Product Change Notification

PCN-FDC-8552-2023

Description for Product Change Notification

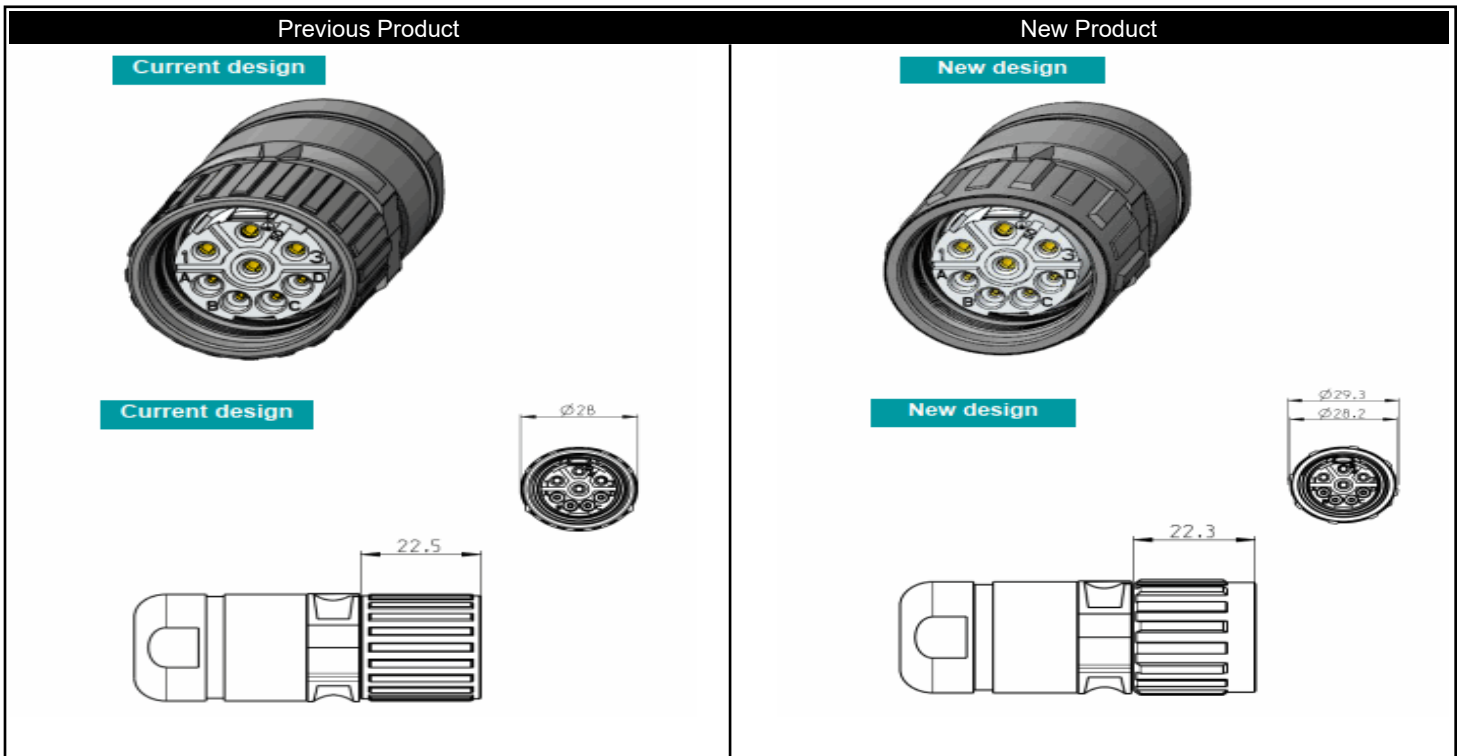
As part of an ongoing improvement process, a design change and material change is being made to the items listed. The change to the knurl design of the SF series, which was planned for 2019, can now be finalized after further technical adjustments.

To improve the bite, the knurl design was adapted using more ridges. Furthermore, the knurl material is changing from brass (turning process) to die-cast zinc (out-of-tool production process). This will improve supply capability and help to clear out existing backlog. Due to the difficult delivery situation, this change needs to be completed in less than 6 months.
